Attachment B – Written Testimony

Fairland and Briggs Chaney Master Plan Work Session #1

Fairland and Briggs Chaney Master Plan Update (March 2023)

Recommended Configuration

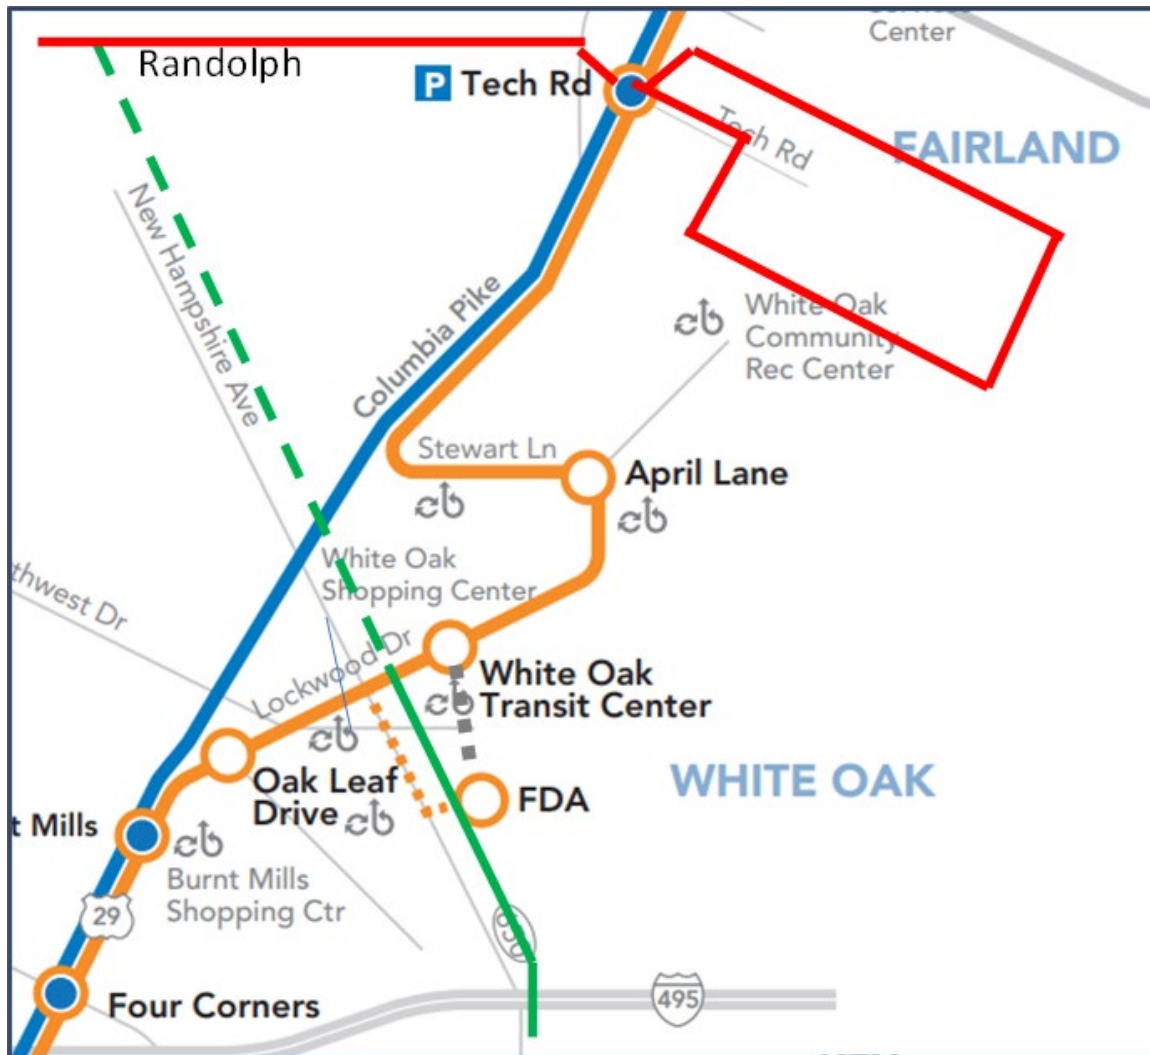
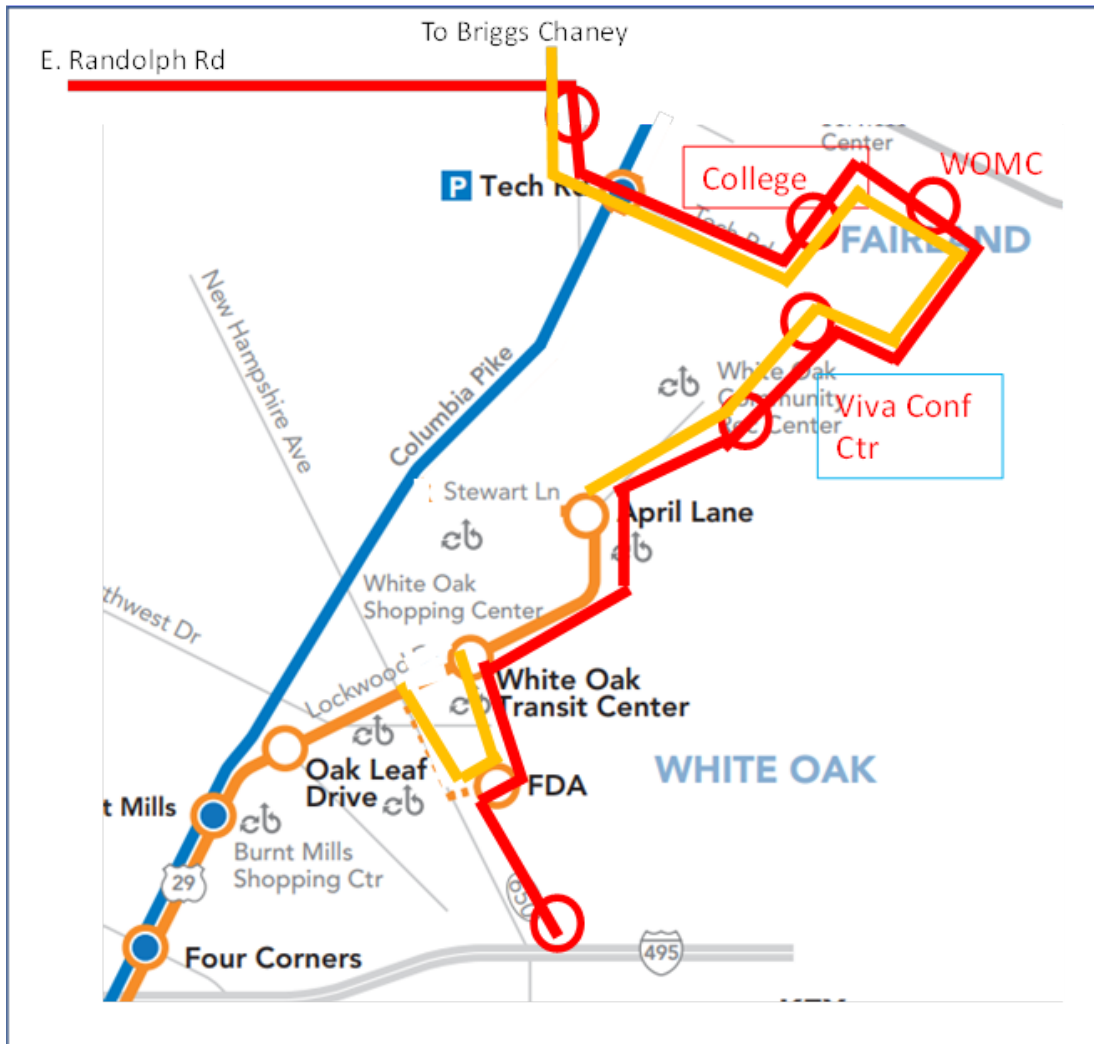
The proposed Flash configuration integrates four BRT corridors. (The US29 corridor is actually two: Blue from Burtonsville and Orange from Briggs Chaney.) The four corridors are US29 Blue and Orange, Randolph Road and New Hampshire Ave. The configuration is illustrated in Figure 1 and consists of the following:

Map 36: Briggs Chaney (South) Activity Center Detail

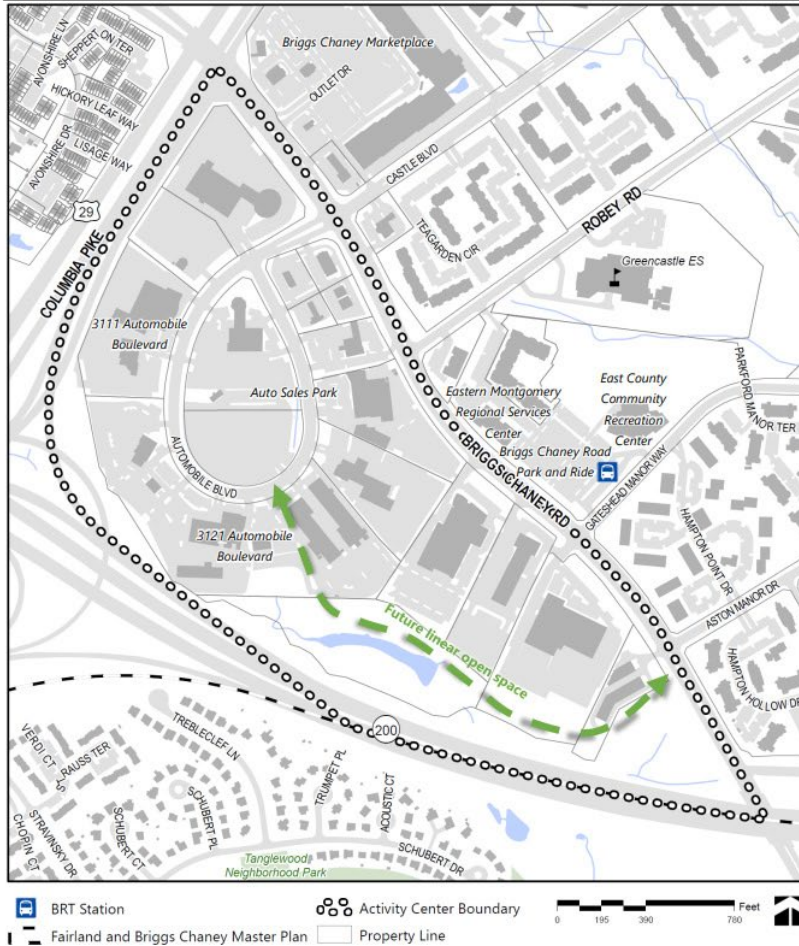
The Master Plan identifies the Property as Map #19F and recommends rezoning the Property from the current GR-1.5, H-85 Zone to CR-2.0, C-1.5, R-1.5, H-85 to “[a]llow for higher-density, mixed-use development.” (Master Plan, p. 97). As stated above, DARCARS’ intention is to expand upon the automobile sales and service uses at the Property to allow for this use to continue for many decades into the future. Given that there is no intention to reposition this Property for mixed-use development, it is important that the Master Plan support and enhance continued automobile uses at the Property.
